Ethan Meltzer, Assistant Planner  
City of Sacramento Community Development Department  
300 Richards Blvd., 3rd Floor  
Sacramento, CA 98811

**RE: The Cove re-routing (P17-051)**

Figure 1 Suggested Completion of Community Paseo

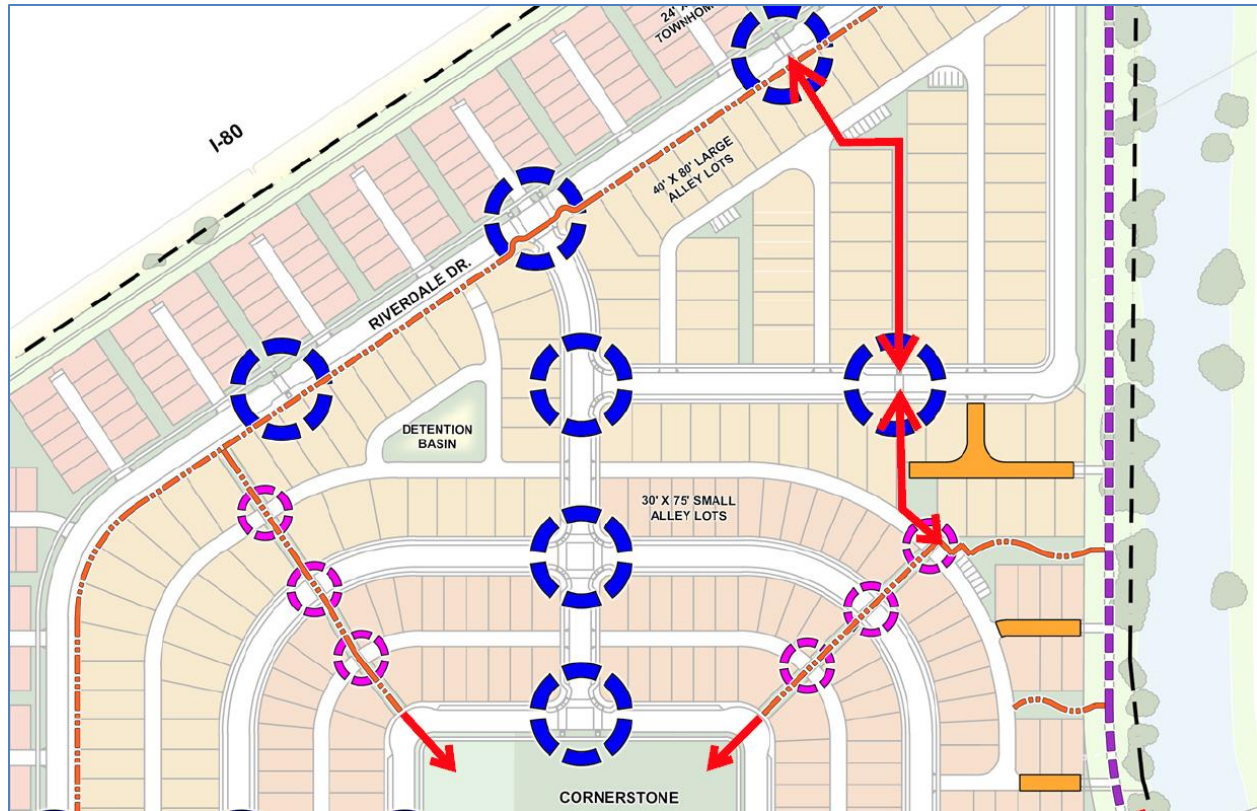
The mega-block created by Riverdale Drive, J Street, L Street and K Street in the northeast corner of The Cove remains a barrier to connectivity. As shown in Figure 1, below, there may be an opportunity to complete the eastside north-south connectivity. The park on Lot AI is not effectively located because it's near a corner of the development and across the street from the large open space encompassing the bike path and canal. **If Lot AI was moved west to provide an opening between Riverdale Drive and Lot BG (Alley 20), and an opening was created between Lot AF and L Street immediately south of the street crossing and the common area landscape Lot AH, a complete community paseo could be added between Riverdale Drive and Cornerstone.**

Figure 2 Revised Routing Bridge Location

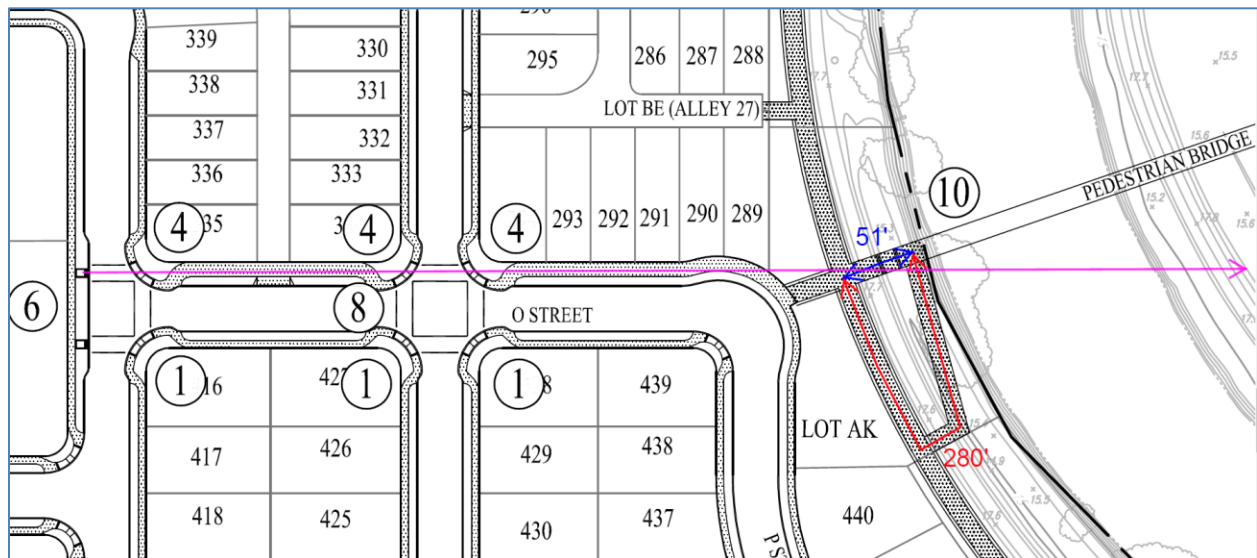
The "enhanced pedestrian corridor" on the north side of O Street will also contribute to a visual corridor between the park and the pedestrian bridge over the canal. Figure 2, below, shows that the bridge will be out of view from most of the sidewalk within the corridor. The figure also shows the direct route using the stairs up to the bridge is about 51', while the ADA path of travel is about 280' and requires backtracking.

If the bridge were moved to the south as shown in the Figure 3, below, the midpoint of the bridge would be visible from the sidewalk over the entire corridor, most of the bridge would be visible from the park, and the ADA path of travel would be about 30% shorter while the direct path via the stairs, although 50' longer, would still not require backtracking. The main benefit, though, may be greater use of the bridge by pedestrians and bicyclists.
